Report FL #: 10088 for Greenheck models EHH-601D & ESD-635D (both w/ and w/o VCD-40 Damper)

Report FL #: 10093 for Airolite models SCH601MD & K6746MD (both w/ and w/o VCD-40 Damper)

NOTICE OF ACCEPTANCE (NOA)

APPROVAL DOCUMENT: Drawing No. **EHH-601D**, titled "EHH-601D Louver", sheets 1 through 35 of 35, dated 08/09/2017, prepared by Greenheck Fan Corporation, signed and sealed by Wayne K. Helmila, P.E. on 09/27/2024, bearing the Miami-Dade County Product Control revision stamp with the Notice of Acceptance number and expiration date by the Miami-Dade County Product Control Section.

GREENHECK P.O. BOX 410 SCHOFIELD, WISCONSIN 54476-0410	DRAWN BY MES	DATE 8/9/2017
	SCALE	
	SHEET NO. 11 OF 35	
TITLE EHH-601D LOUVER FLANGE FRAME SLEEVE MOUNT MULLION DETAILS H≤144" & H≤96"	CAD DRAWING NO. EHH-601D

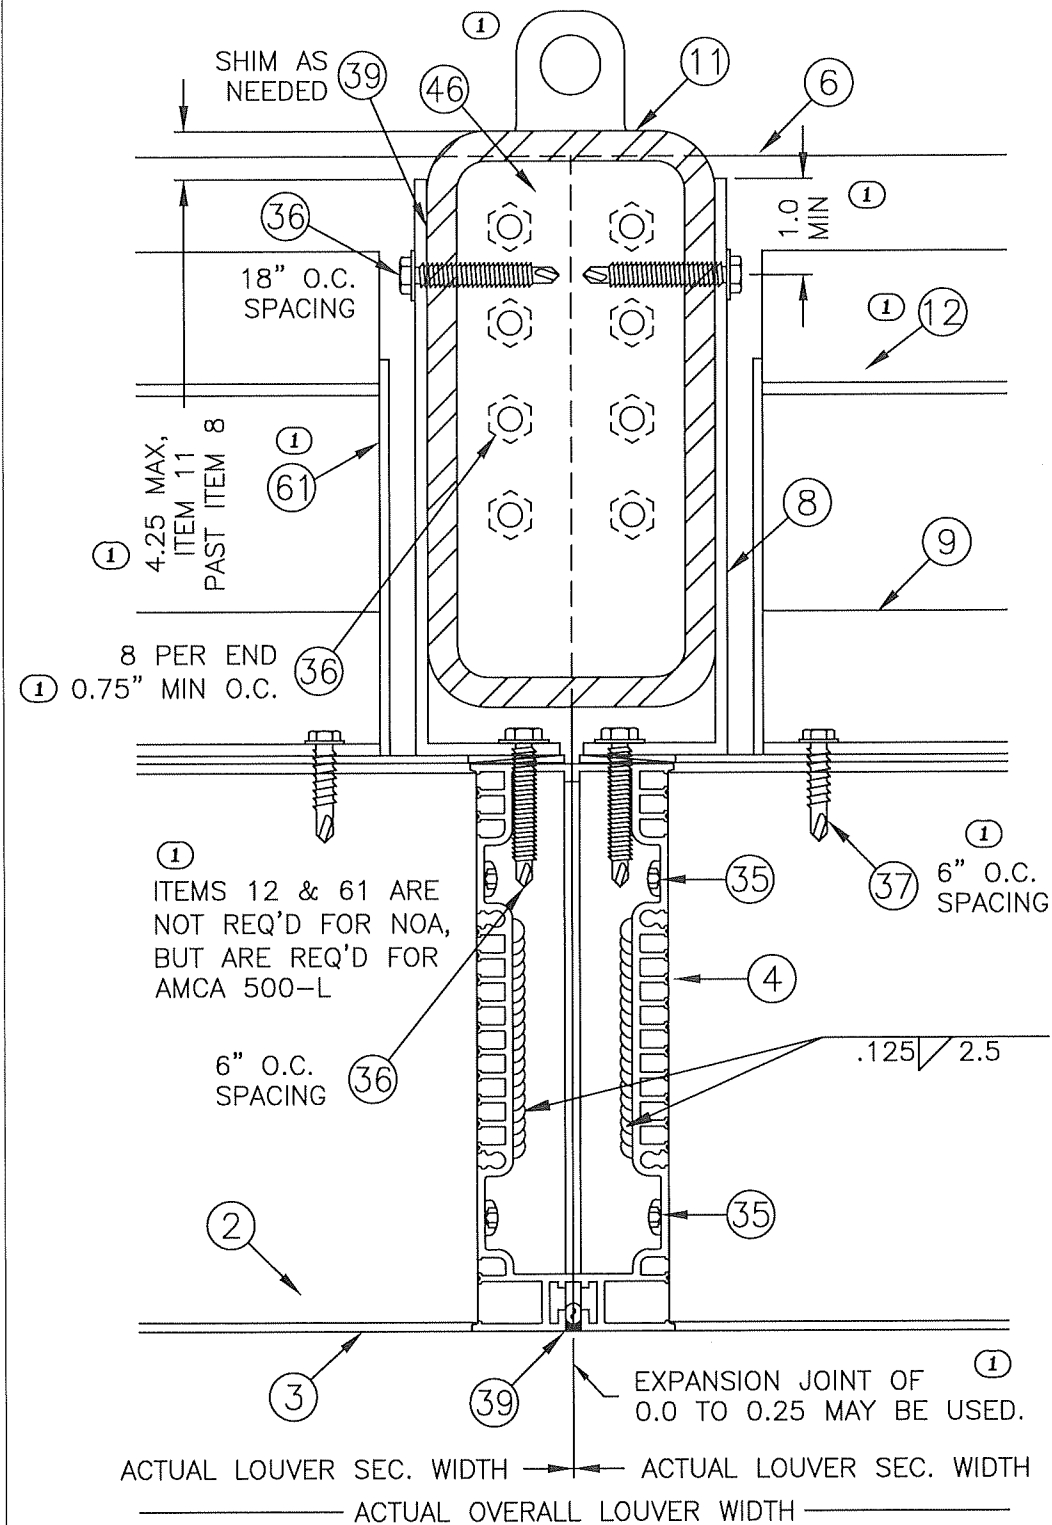
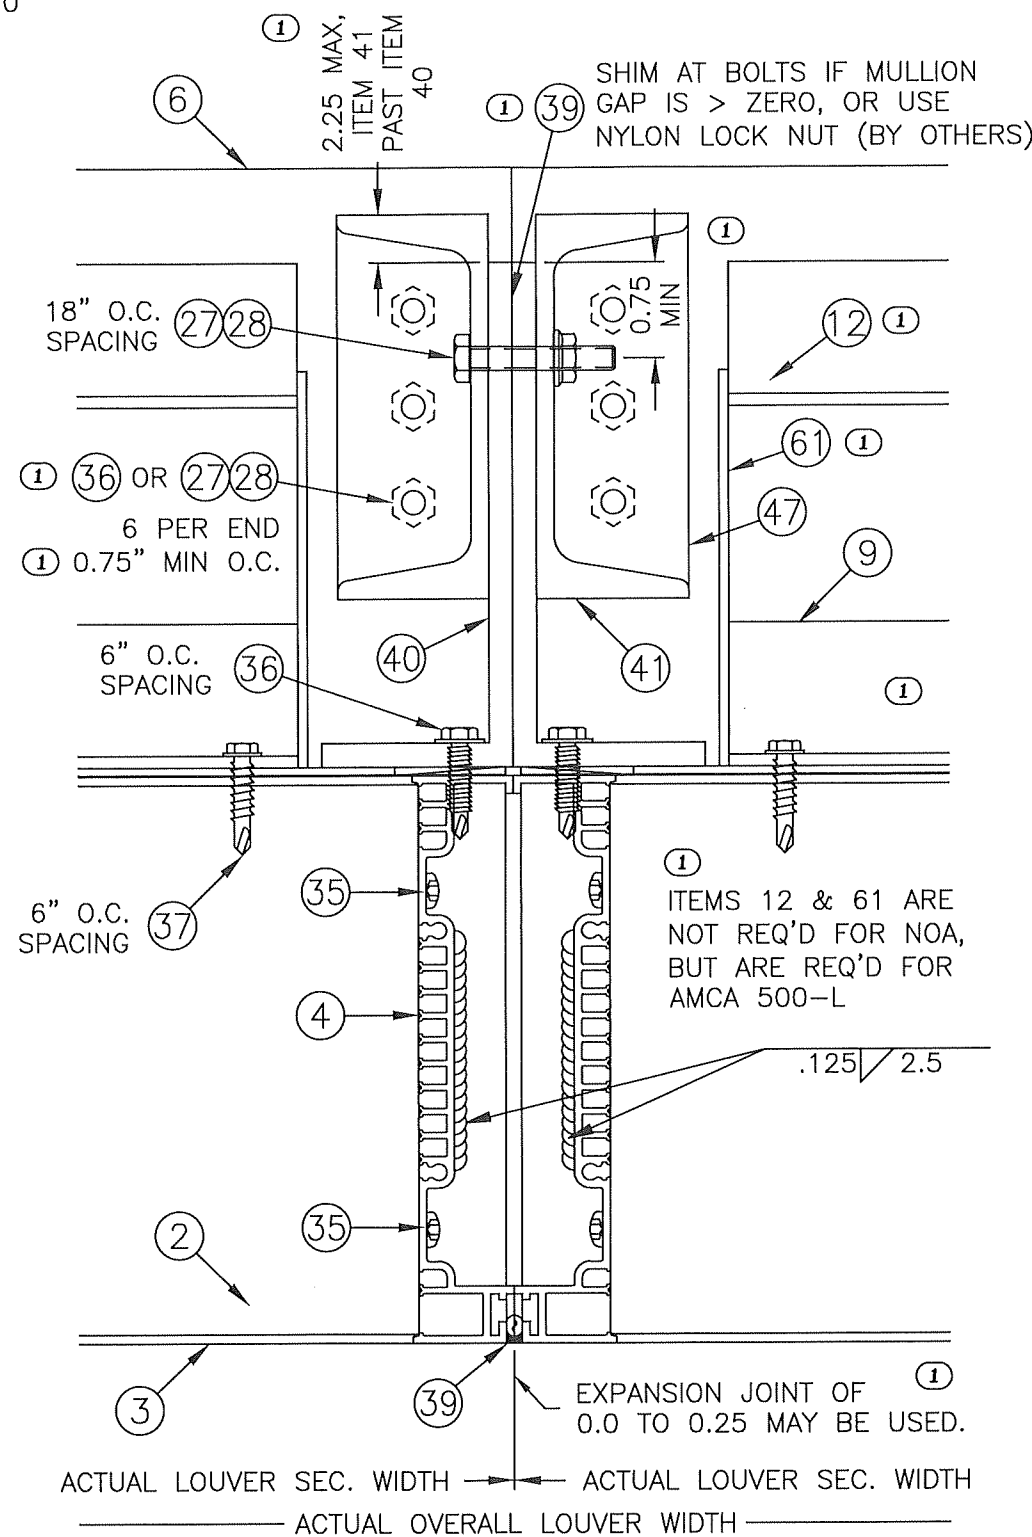
REV 01: 8/1/24, WAS PAGE 10, ADDED LIFTING LUG, REDEFINED ITEM 11 & 41 MAX OFFSETS, ADDED 0.75 & 1.0 MIN OFFSETS, ADDED ITEM 39 CALLOUT, ADDED ON CENTERS OF 6" X1 & 0.75" X2, ADDED ITEM 9 & ETC. TO DETAIL 13B, ADDED ITEM 12 WITH NOTE X2, ADDED ITEM 36 OPTION, ADDED ITEM 61 X4 & ITS CALLOUT X2, & REWORDED MULLION GAP NOTE X2.

14A
12
MULLION DETAIL, W/ END PLATE MOUNTING
LOUVER HEIGHT ≤ 144 IN.
CONTINUOUS ANGLE MOUNT

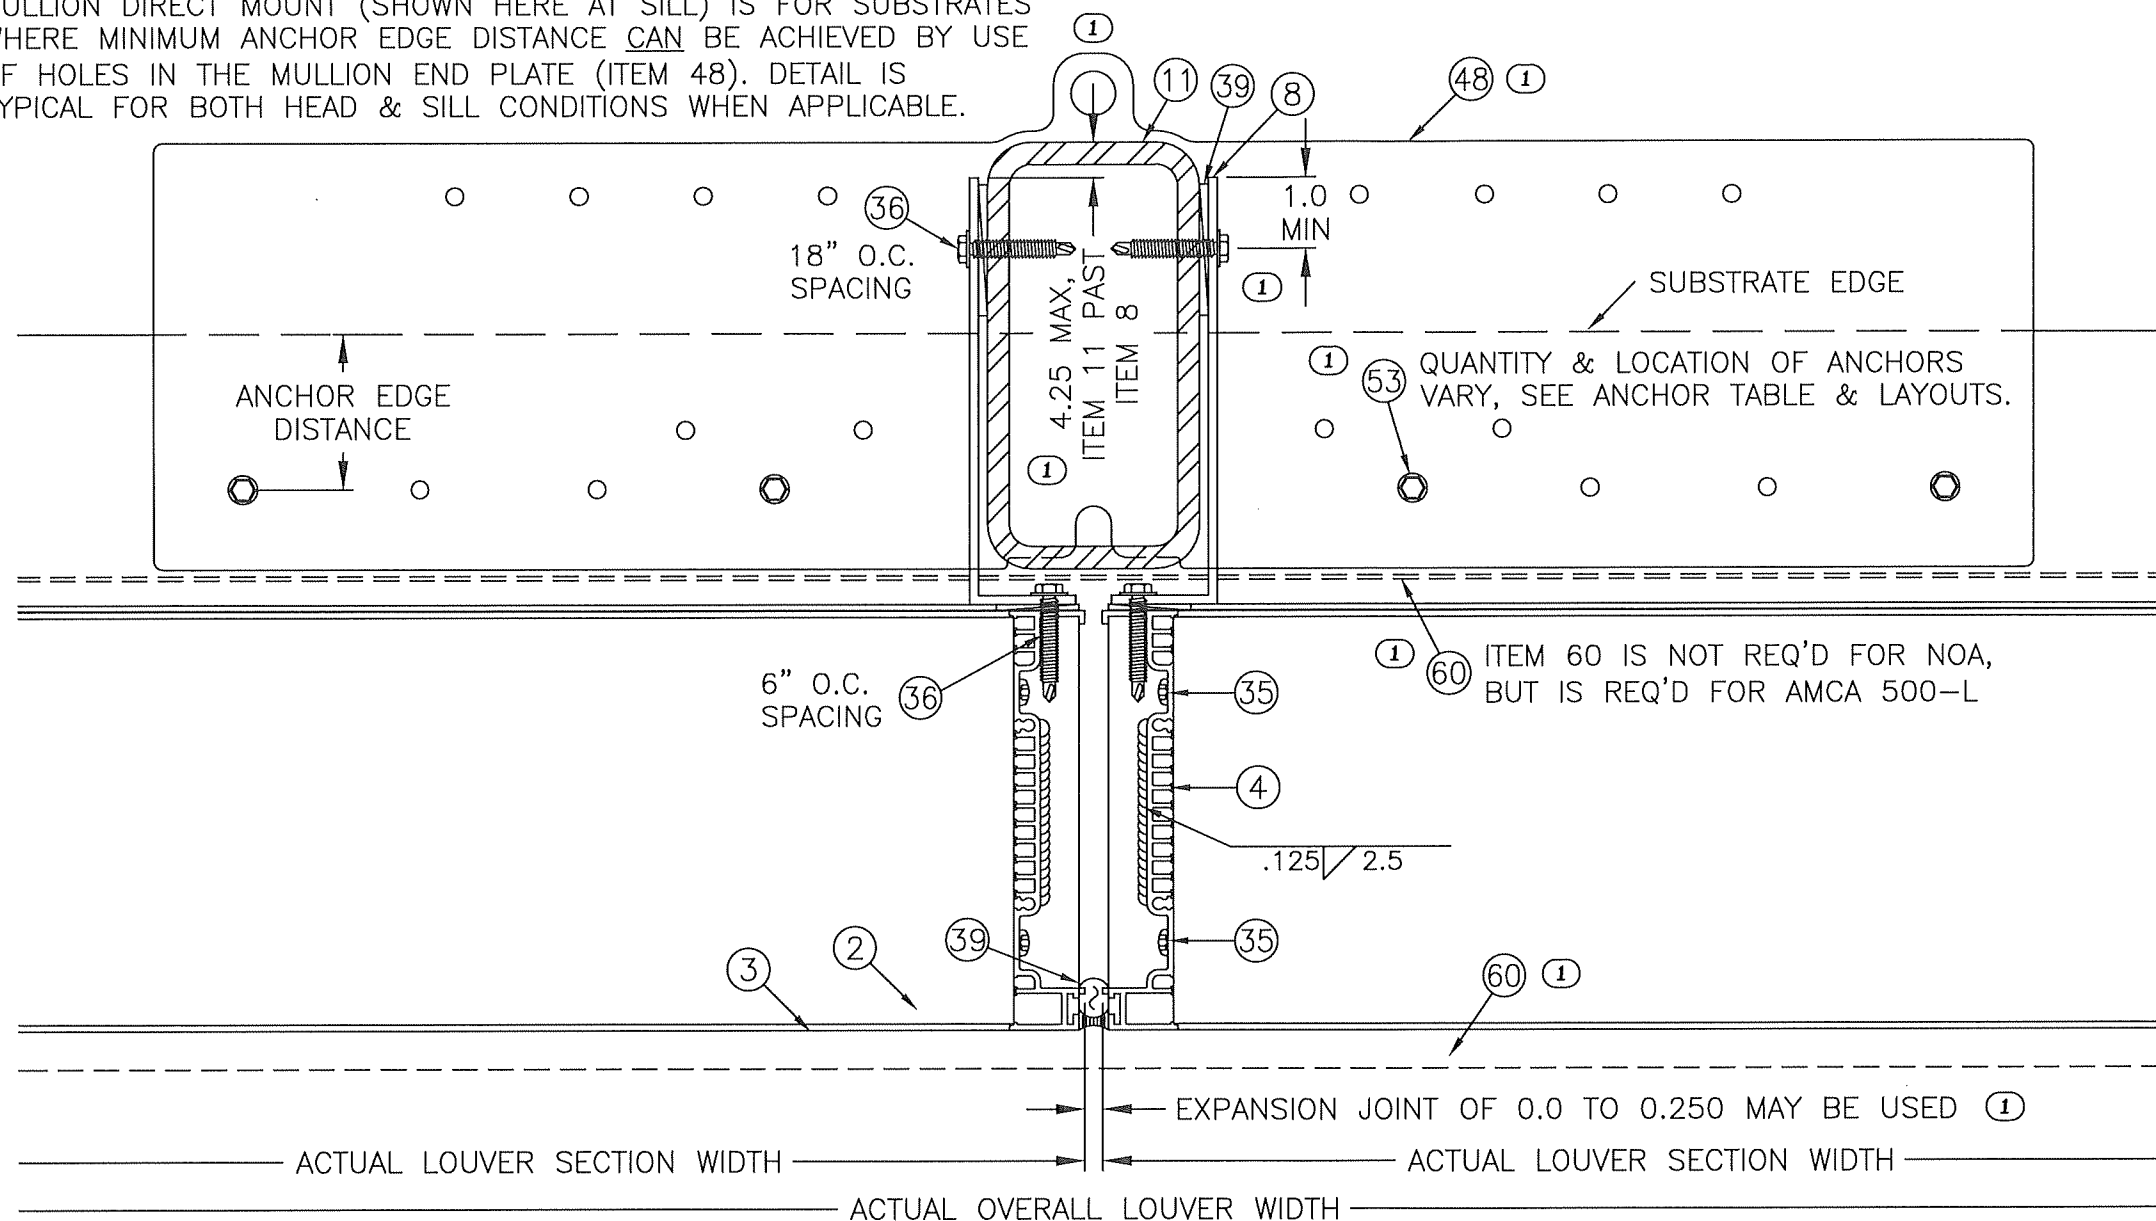
REV 01: 8/1/24, WAS PAGE 11, MOVED DETAIL 14B TO A NEW PAGE, ADDED LIFTING LUG, REPLACED ITEM 48 WITH UPDATED DESIGN, REDEFINED ITEM 11 MAX OFFSET, ADDED 1.0 MIN OFFSET, UPDATED ANCHOR REFERENCE NOTE, REWORDED MULLION GAP NOTE, & ADDED ITEM 60 X2 & ITS NOTE X1.

14B MULLION DETAIL, W/ MULLION ANGLE MOUNTING
LOUVER HEIGHT $\leq$ 144 IN.
13 CONTINUOUS ANGLE MOUNT

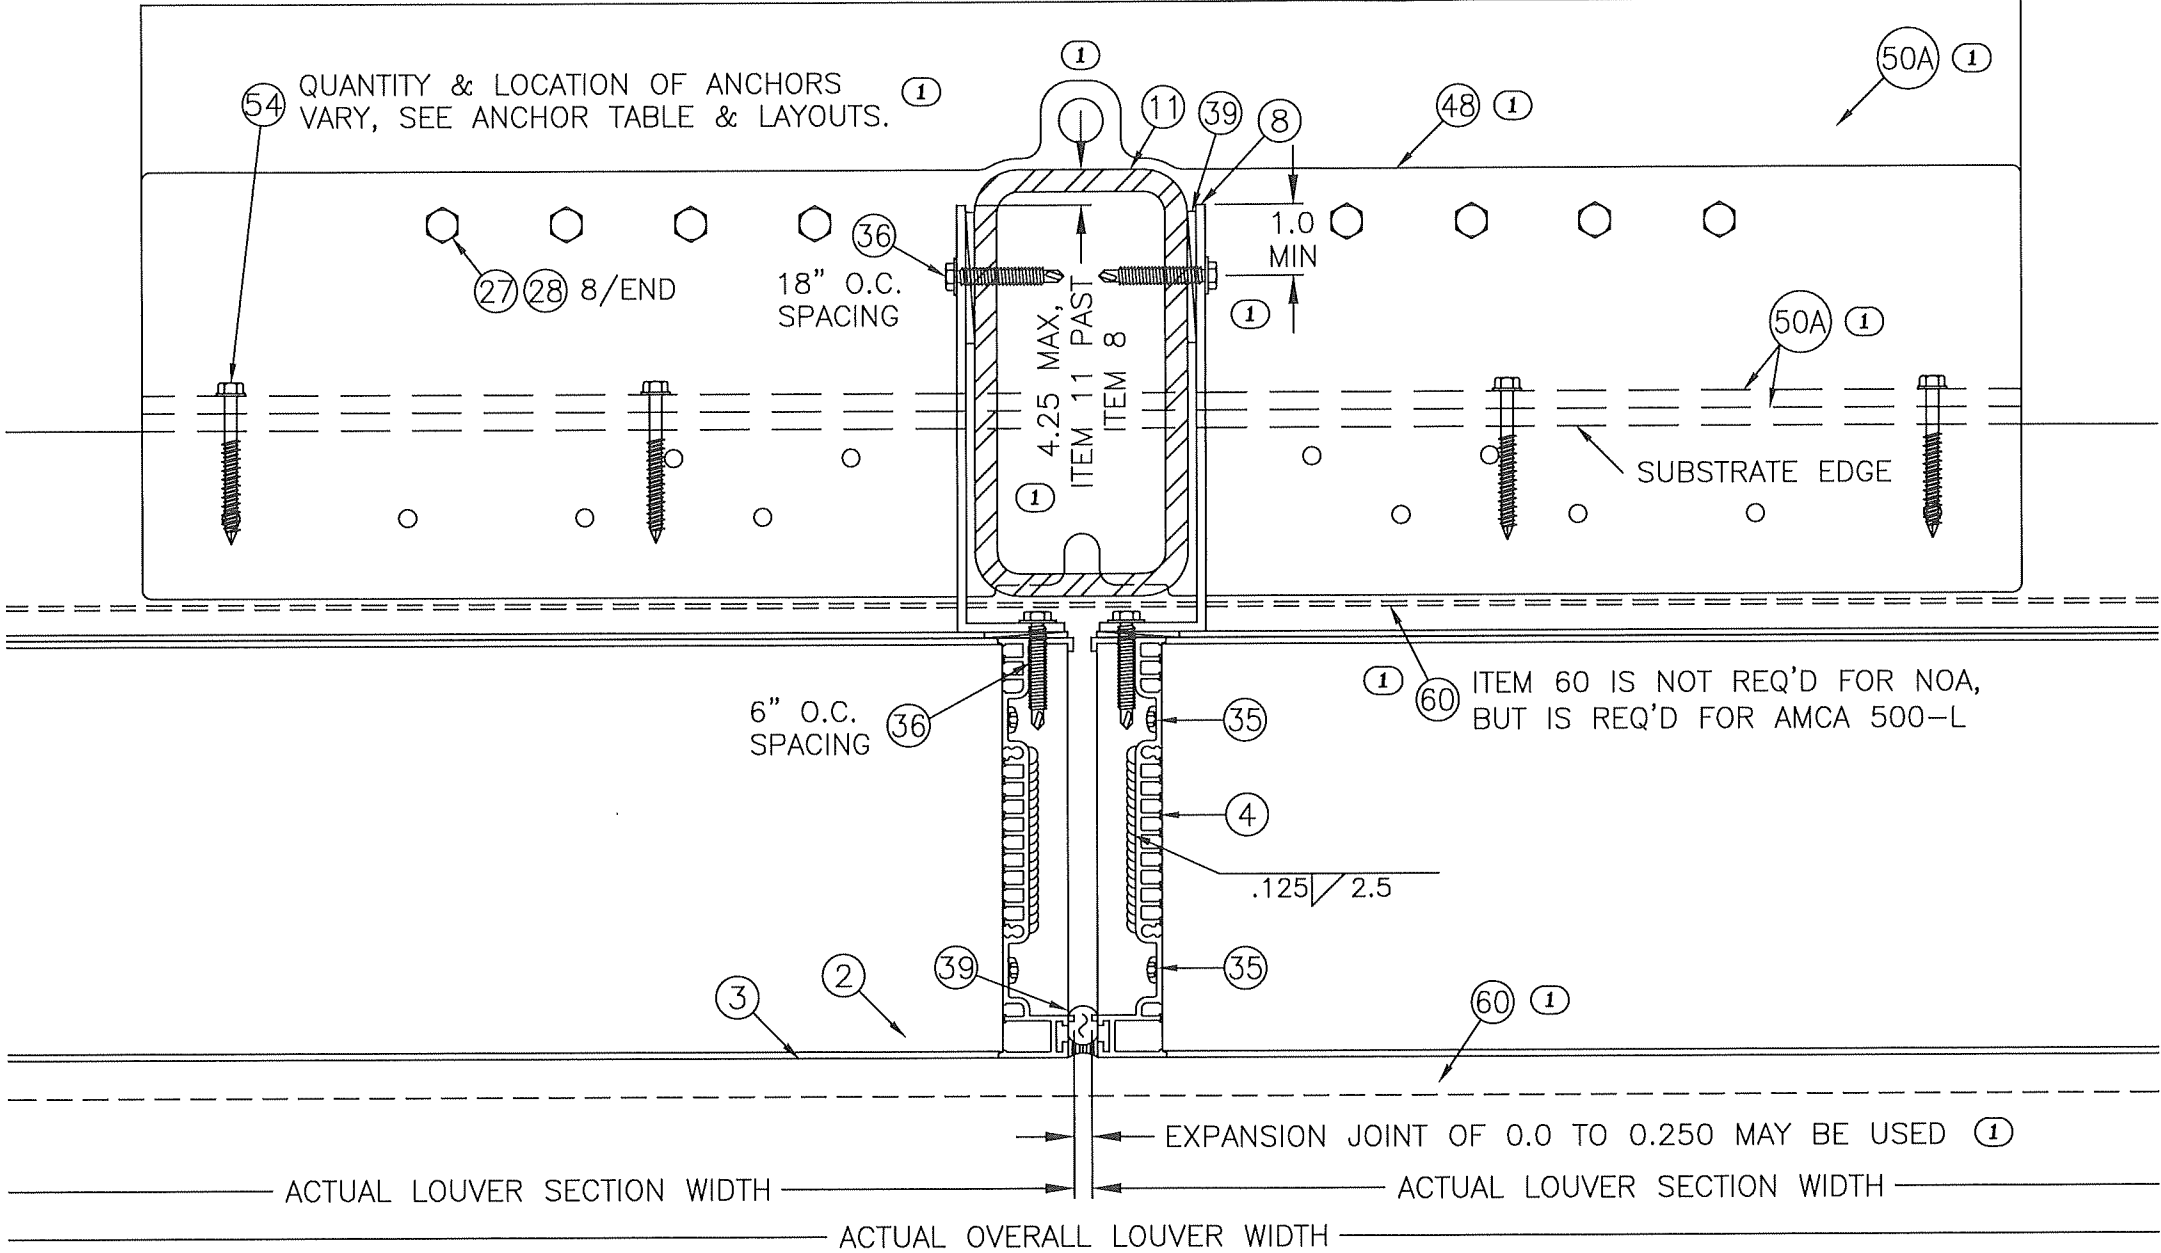
REV 01: 8/1/24, MOVED DETAIL 14B TO THIS NEW PAGE, ADDED LIFTING
LUG, REPLACED ITEMS 48 & 50A WITH UPDATED DESIGNS, REDEFINED ITEM
11 OFFSET, ADDED 1.0 MIN OFFSET, UPDATED ANCHOR REFERENCE NOTE,
REWORDED MULLION GAP NOTE, & ADDED ITEM 60 X2 & ITS NOTE X1.

15A
14
MULLION DETAIL, W/ END PLATE MOUNTING
LOUVER HEIGHT ≤ 96 IN.
CONTINUOUS ANGLE MOUNT

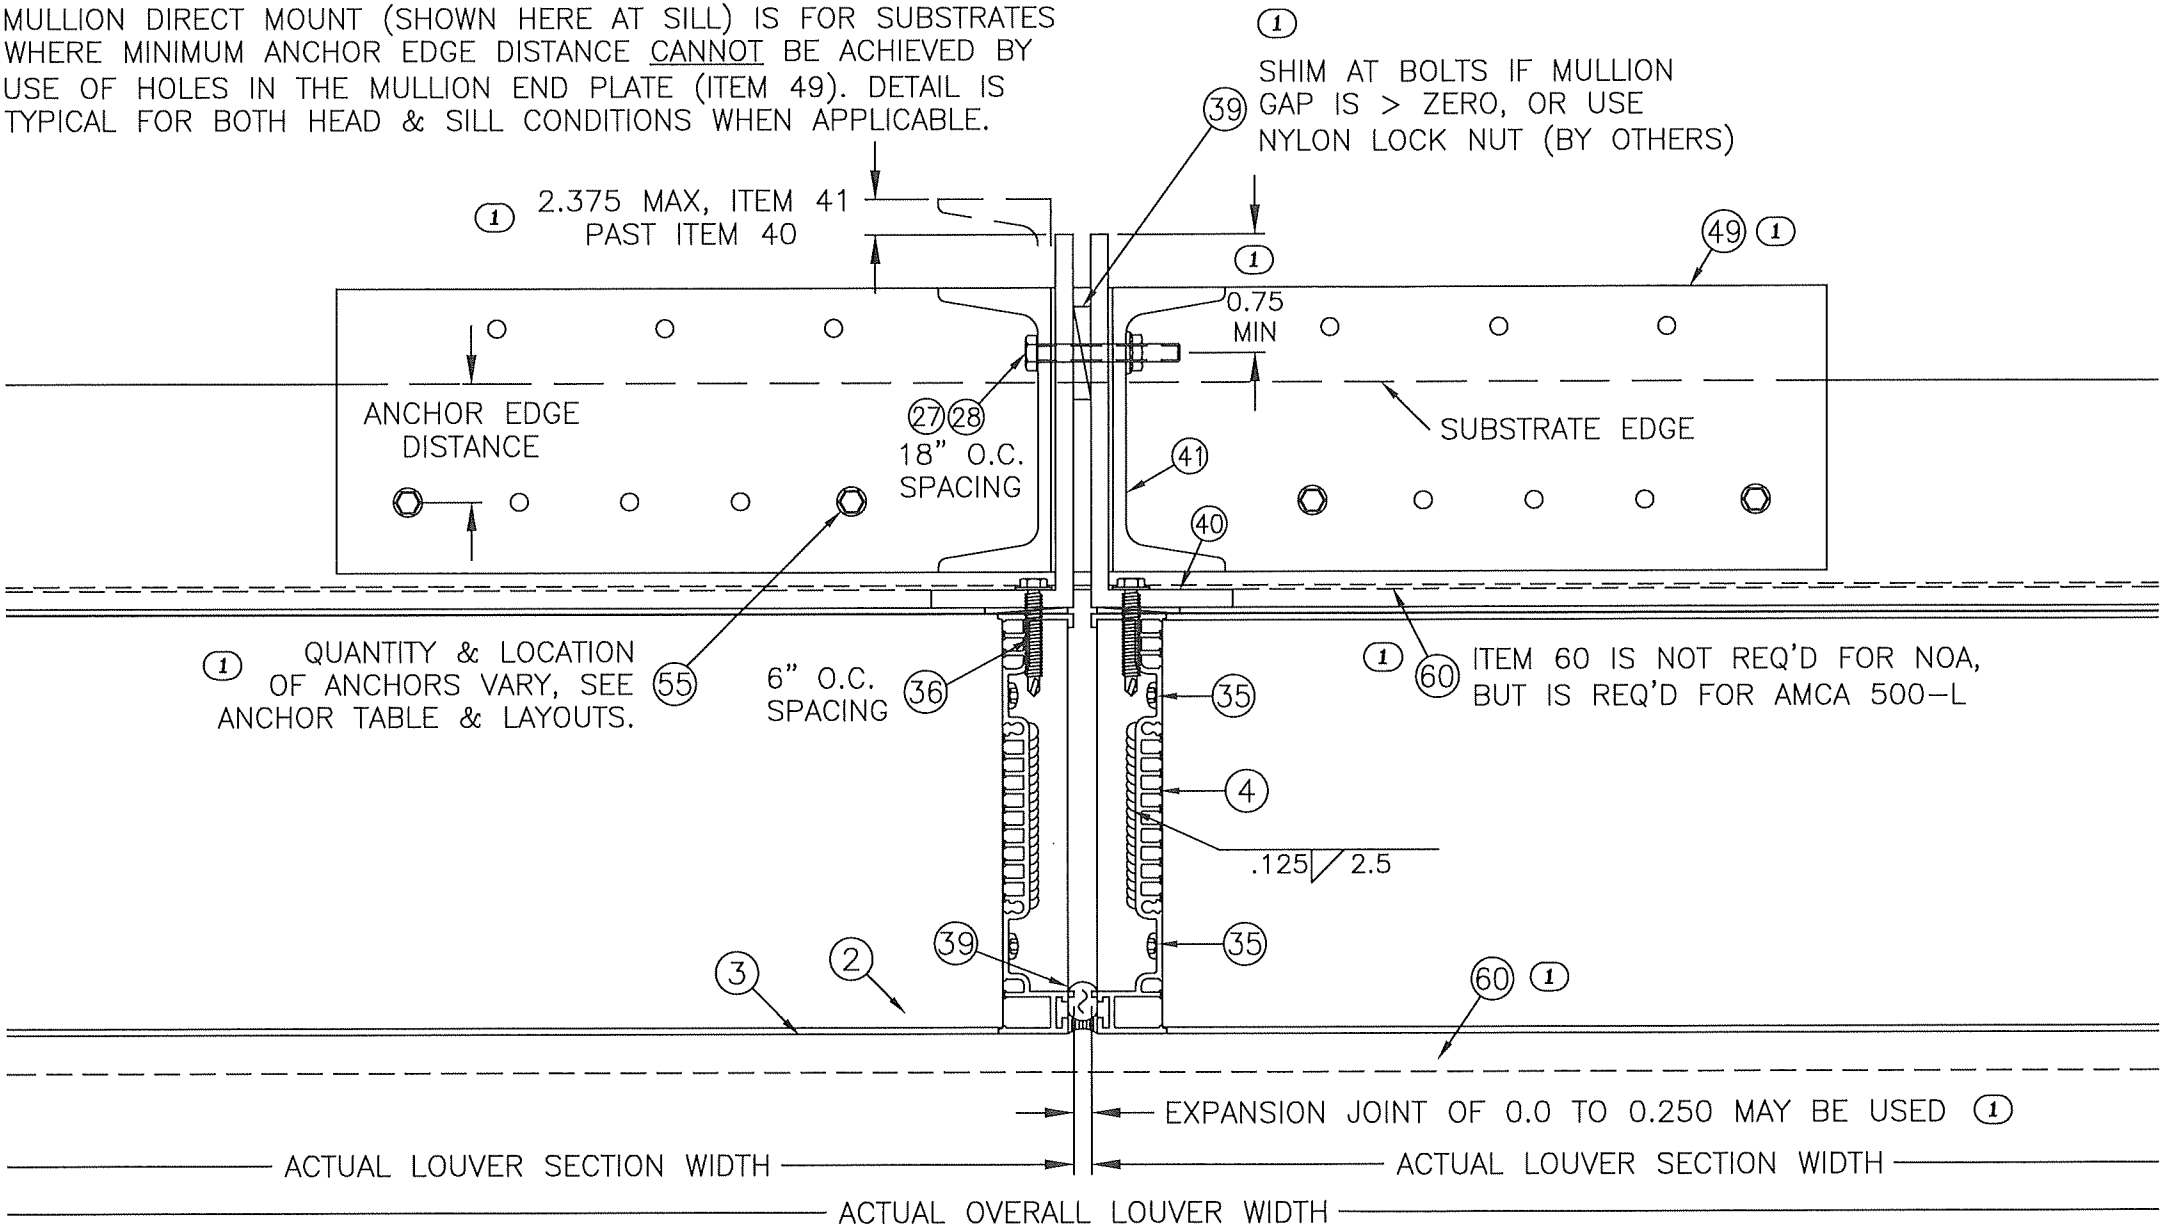
REV 01: 8/1/24, WAS PAGE 12, MOVED DETAIL 15B TO A NEW PAGE, REPLACED ITEM 49 WITH UPDATED DESIGN, REDEFINED ITEM 41 MAX OFFSET, ADDED 0.75 MIN OFFSET, ADDED ITEM 39 & NOTE, UPDATED ANCHOR REFERENCE NOTE, REWORDED MULLION GAP NOTE, & ADDED ITEM 60 X2 & ITS NOTE X1.
